**Investigation into Alleged Environmental Violations by
Central Coalfields Ltd in Amrapali OCP:**

**Report of Committee appointed by Hon'ble National Green
Tribunal in *Sanjay Chauhan vs CCL & Ors (OA 28/2020/EZ)*
*vide order dt.11.05.2020***

Date of submission: 14 September 2020

Figure 2. Map of Amrapali OCP in EIA document of 2006, showing location of CHP (Silo) at top left over proposed dedicated railway siding (blue arrow).

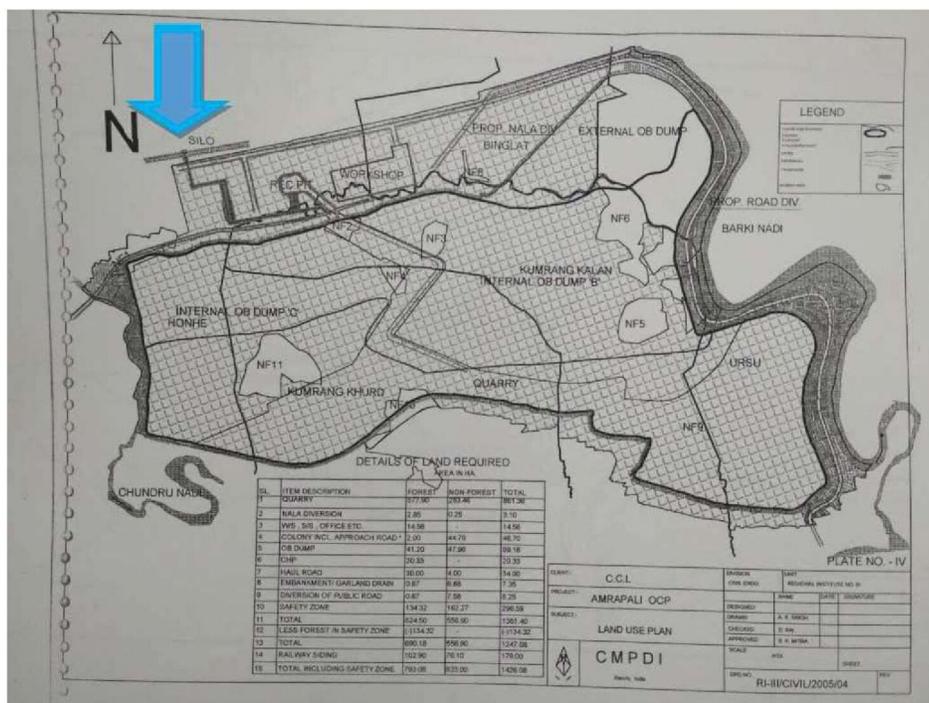
The original EIA/EMP of 2006 clearly showed that a CHP was to be constructed in an area of 20.33 ha (see Figure 2), along with a dedicated rail siding (hereinafter Amrapali railway siding) to be constructed in a loop, for which an area of 179 ha was to be set aside. The EC dt.3.01.2006 also clearly requires the construction of a CHP (Specific Condition xiv).
